Appendix A Brickwork Details | Core

2022 Consented Scheme

2022 Proposed S73

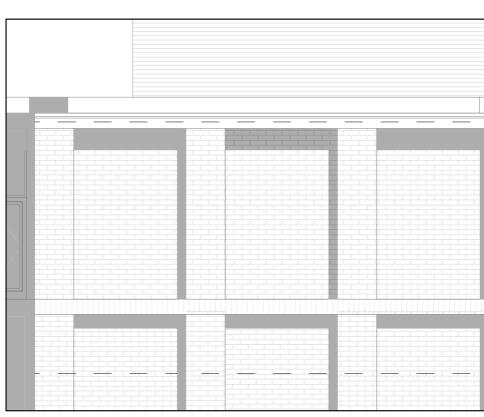
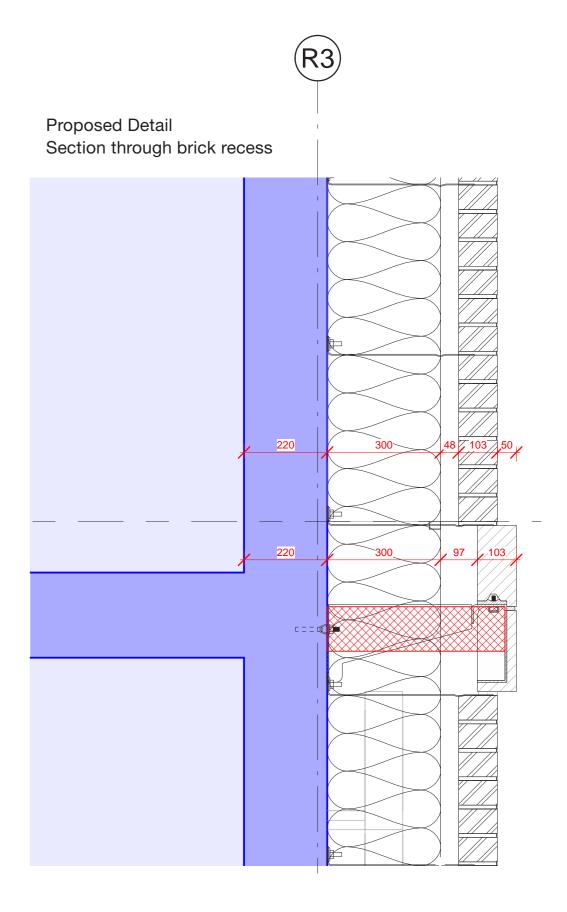
The consented scheme proposes a pattern of recessed blind windows around the core using the pre-cast concrete system. The S73 submission proposes replacing the pre-cast concrete to the rear elevation with brickwork.

In both submissions, 450mm was allowed for the envelope build-up around the core, including both the thicker frame build-up, and the thinner recessed blind windows.

Following technical design and review of brick setting out, 450mm is confirmed as the *minimum* setting out required to provide compliant thermal performance and drainage cavity. To achieve any recessed expression, the recessed build-up will need 450mm, and projections will need more.

To achieve the blind window articulation, and to build to brick dimensions, without losing area to affordable units, this submission proposes that the outer face of the brick envelope be increased by up to 50mm in select locations.

Detail Section: Insulated Brickwork Piers

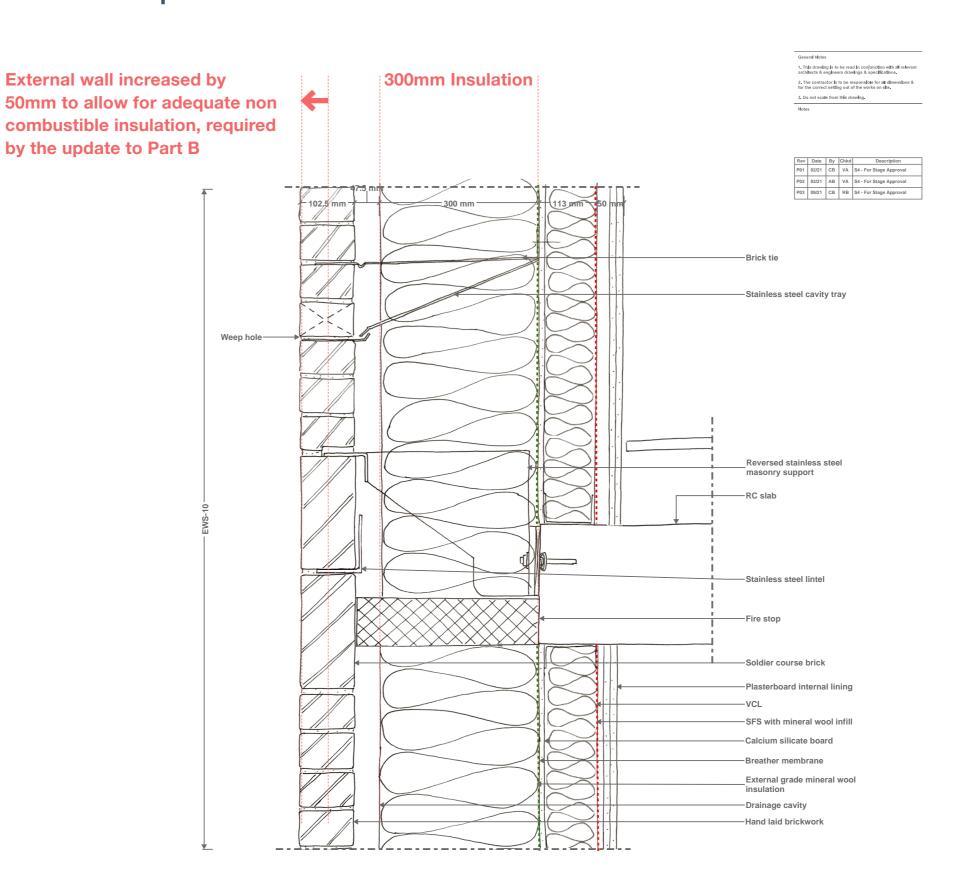
50mm increase

Detail Section: Soldier Course Lintels

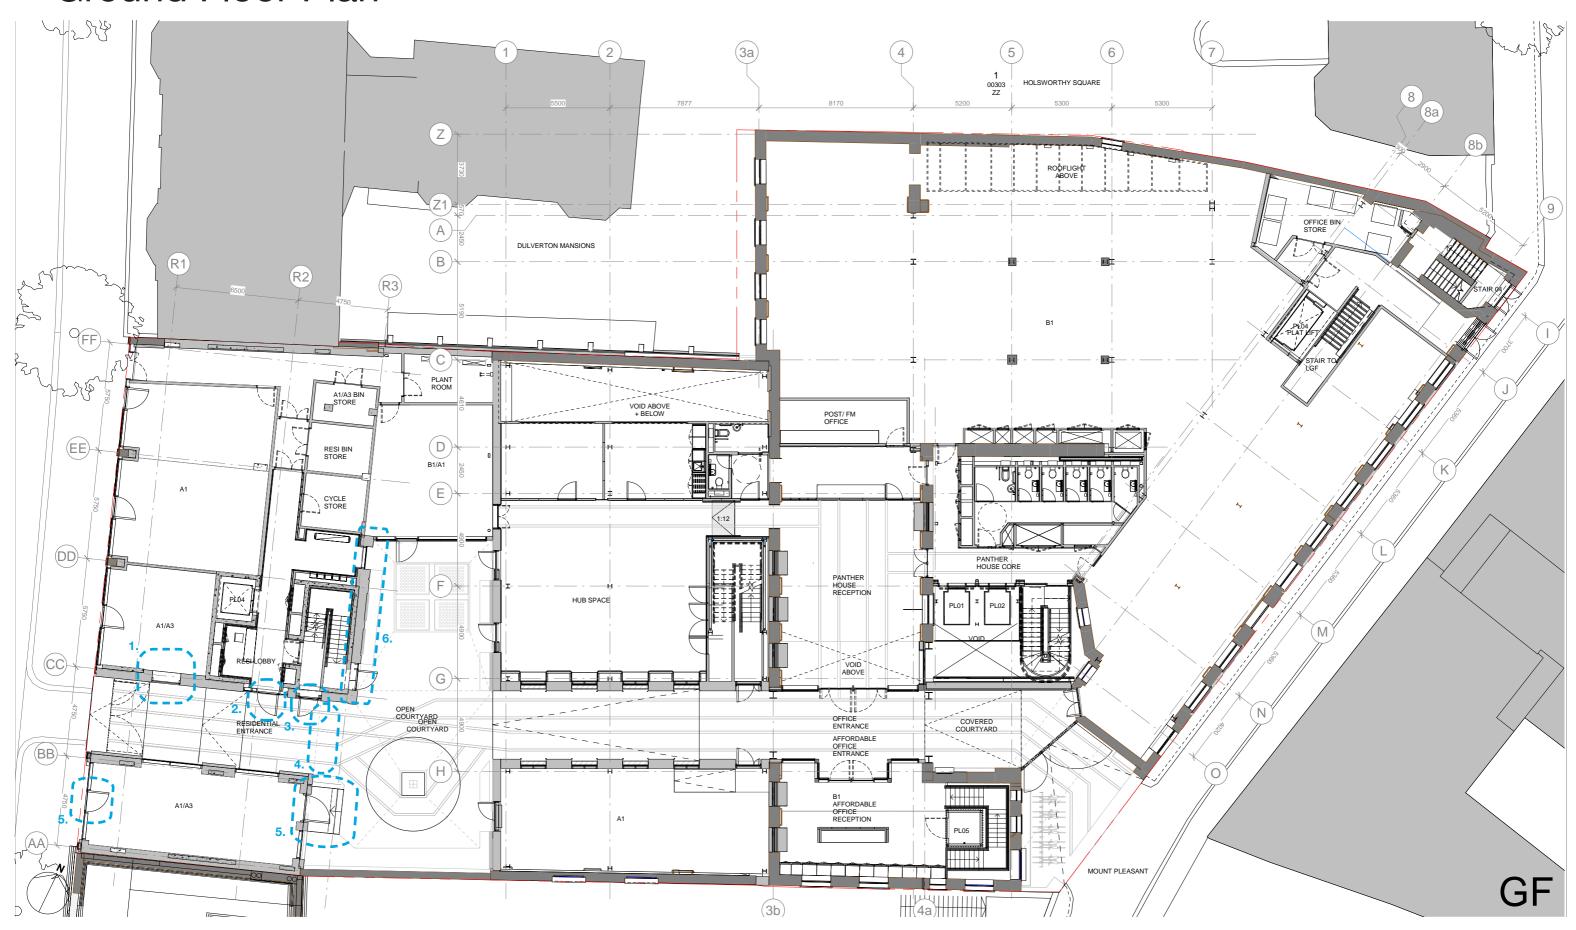
External wall increased

combustible insulation, required by the update to

by 50mm to allow for adequate non

Part B

50mm increase

Ground Floor Plan

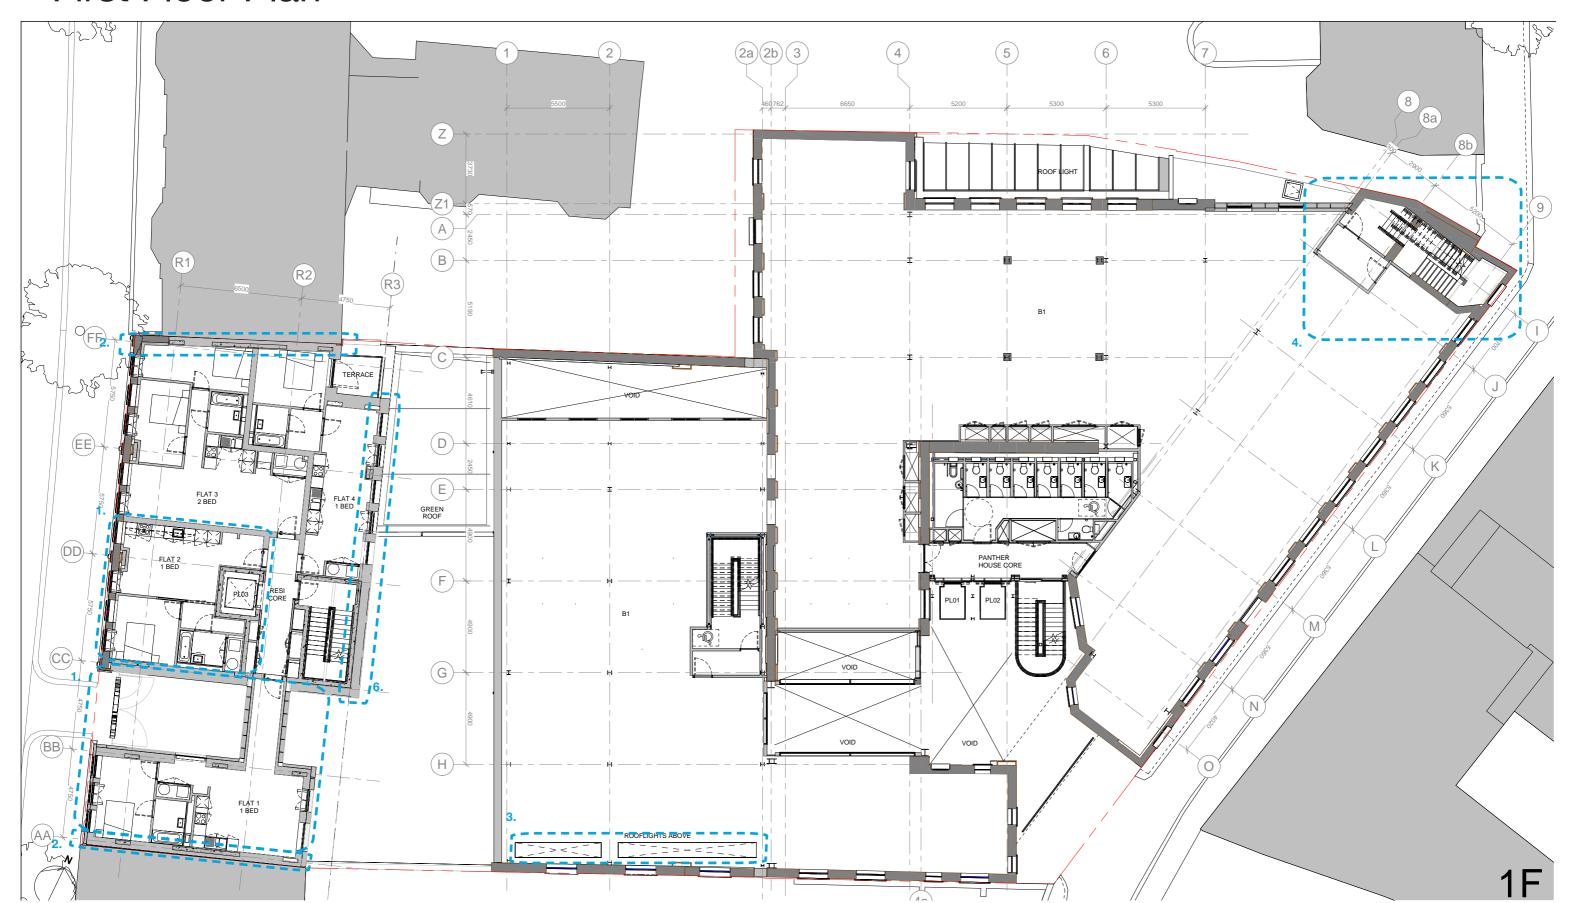
Change of secondary retail door to window
 Change of double door to single door

2. Change of double door to single door3. New door for direct egress to outside from escape stair

4. Omission of second gate5. Level access to Gray's Int

5. Level access to Gray's Inn Road primary entrance to retail unit necessitates level change in courtyard to secondary door

6. External wall to rear expanded 50mm as per Appendix A to allow for greater insulation zone.

First Floor Plan

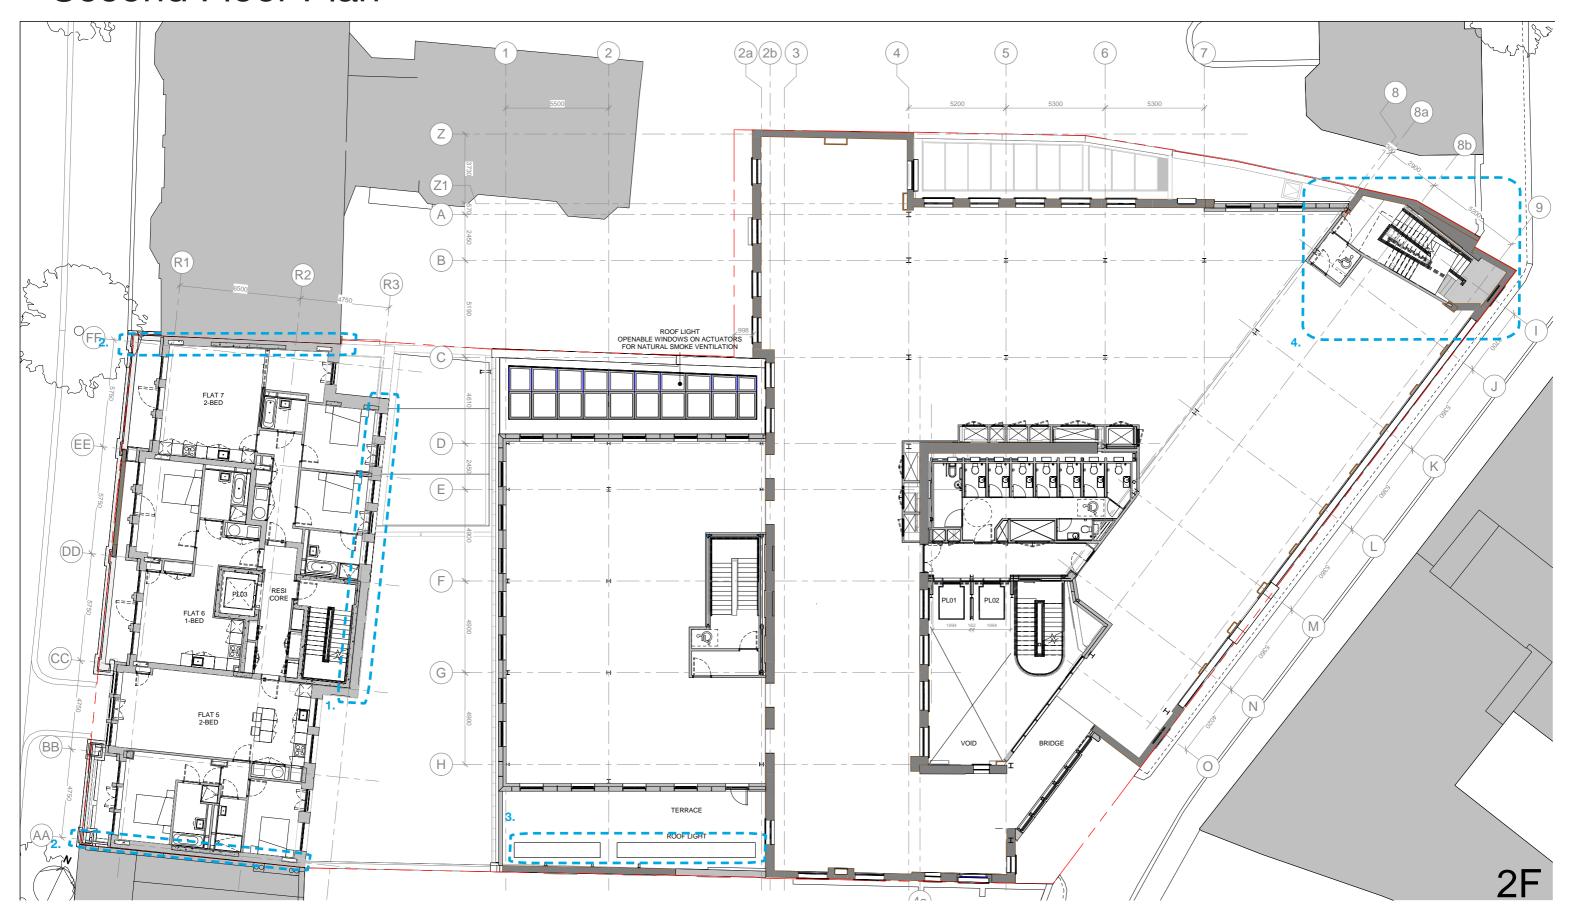
1. Changes to internal layouts of flat 1 and 2 to improve space standards.

2. Enhanced party wall build-up to meet updated guidance

- 3. Rooflights changed to square to "wash" the retained existing glazed brickwork.4. Design development of NE stair and lobby to reflect existing.
- 6. External wall to rear expanded 50mm as per Appendix A to allow for greater insulation zone.
- 7. Bridge widened to create storage areas for flat 1

Second Floor Plan

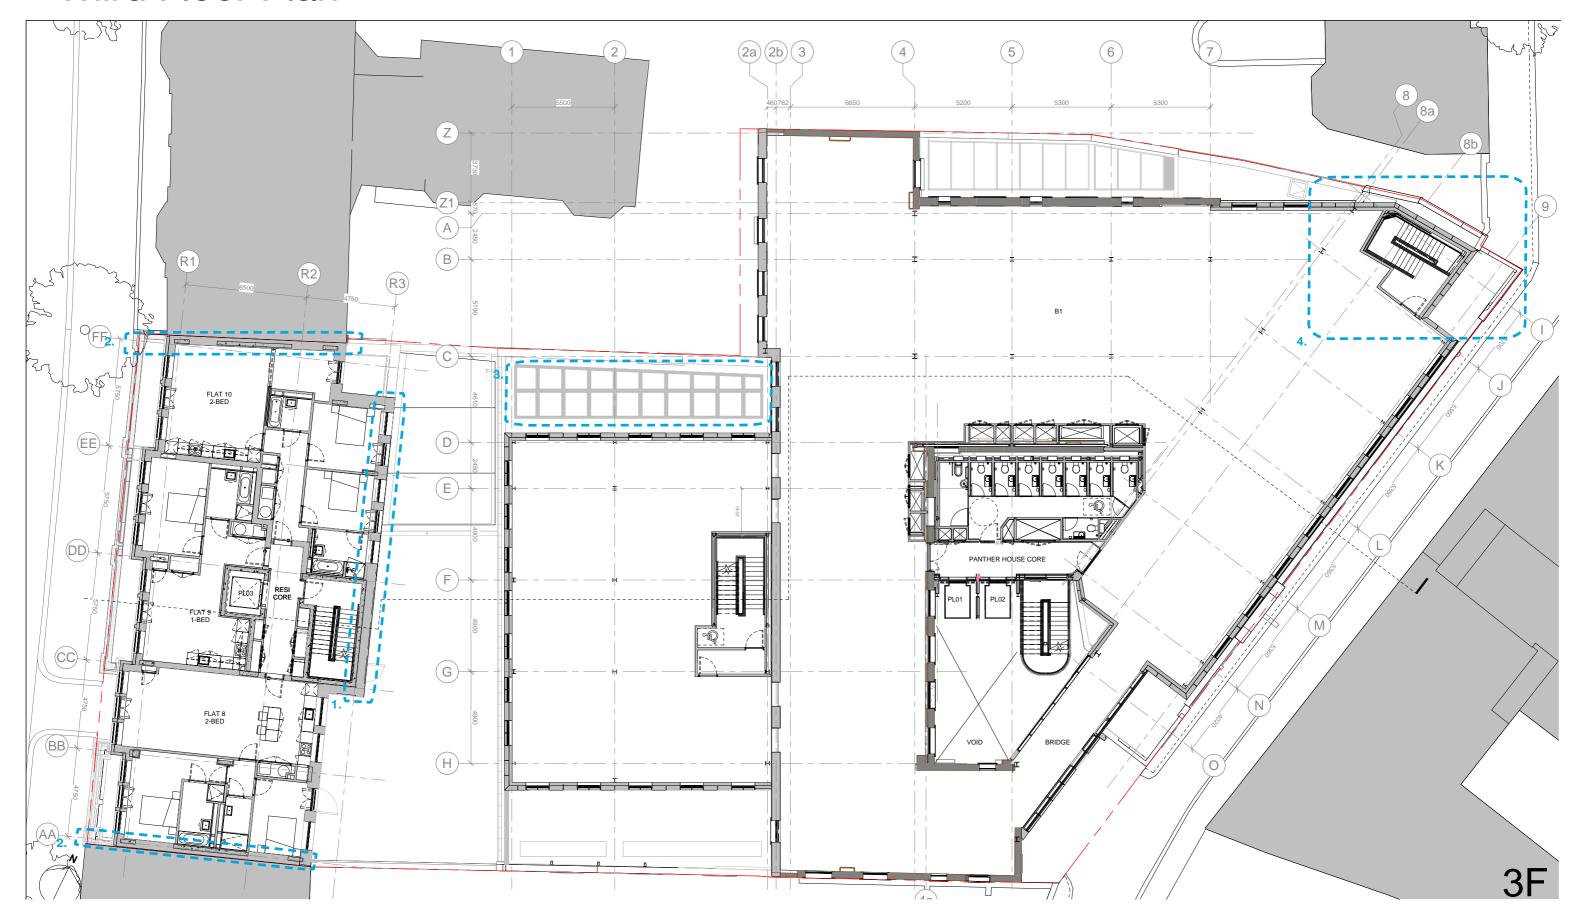
^{1.} External wall to rear expanded 50mm as per Appendix A to allow for greater insulation zone.

^{3.} Rooflights changed to square to "wash" the retained existing glazed brickwork.

^{2.} Enhanced party wall build-up to meet updated guidance 4. Design development of NE stair and lobby to reflect existing.

Third Floor Plan

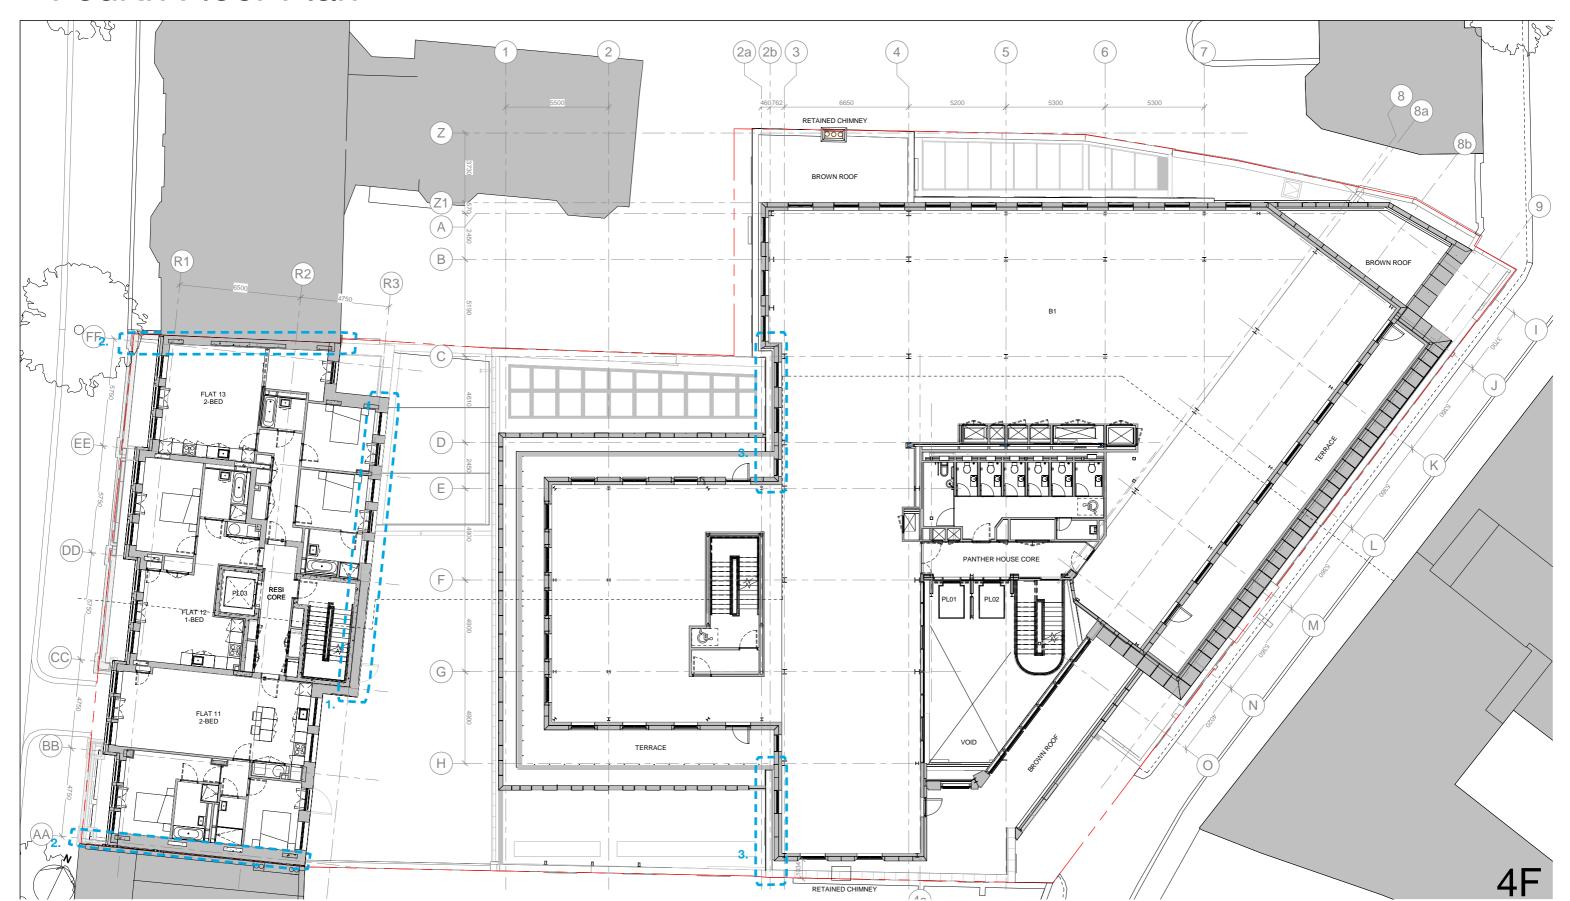
^{1.} External wall to rear expanded 50mm as per Appendix A to allow for greater insulation zone.

- 3. Design development of rooflights to LGF4. Design development of NE stair and lobby to reflect existing.
- 2. Enhanced party wall build-up to meet updated guidance

Fourth Floor Plan

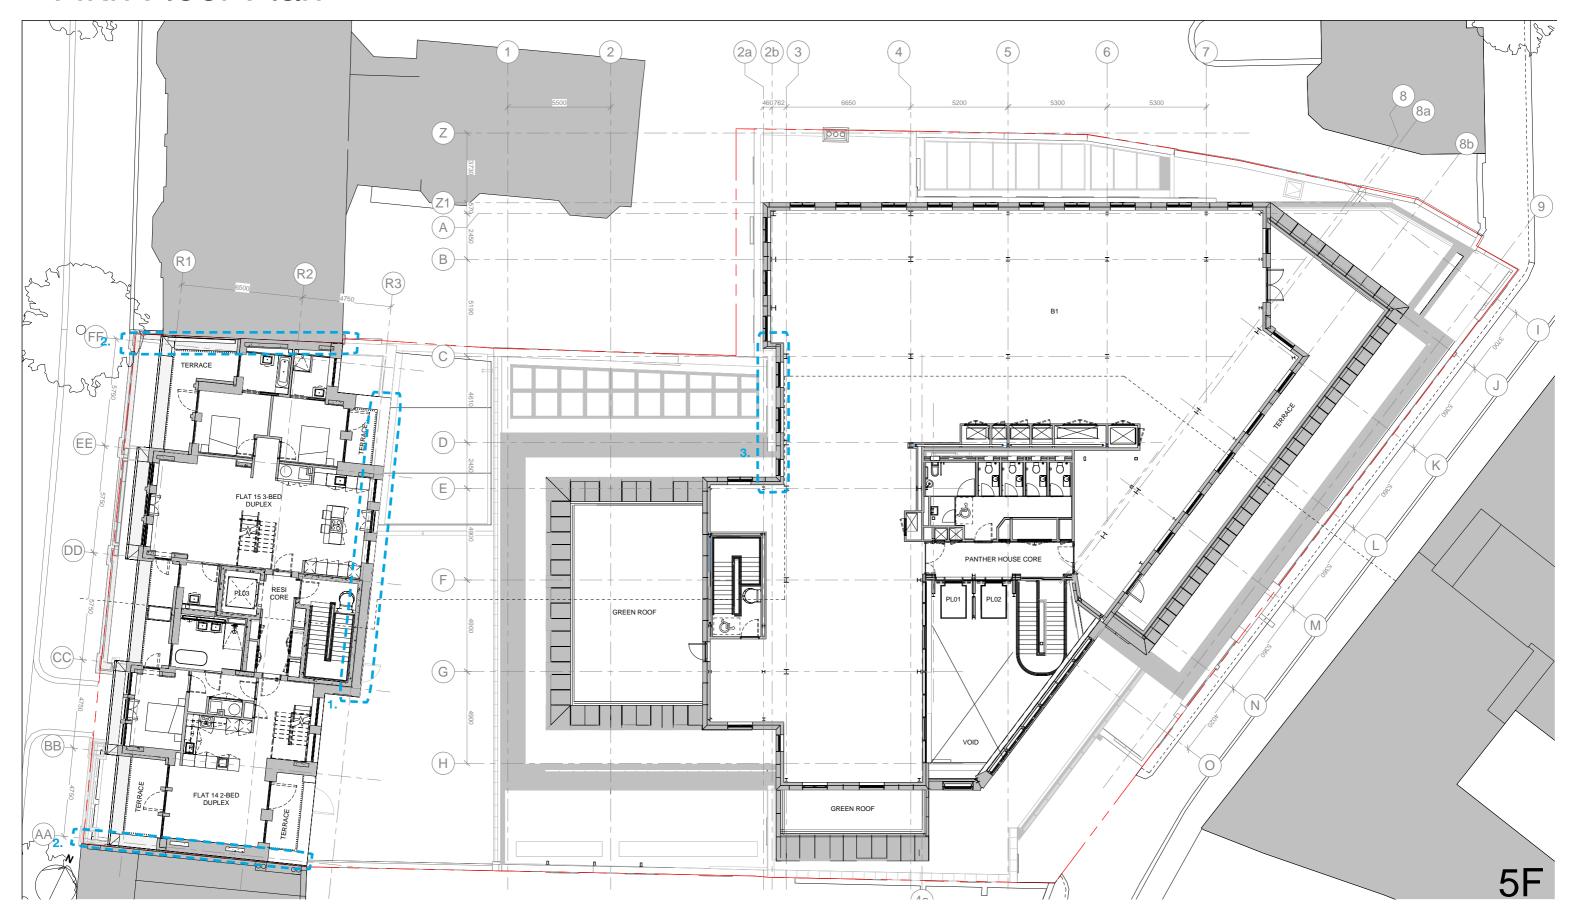
^{1.} External wall to rear expanded 50mm as per Appendix A to allow for greater insulation zone.

^{3.} Extension set in from existing facade to allow for better coping detail.

^{2.} Enhanced party wall build-up to meet updated guidance
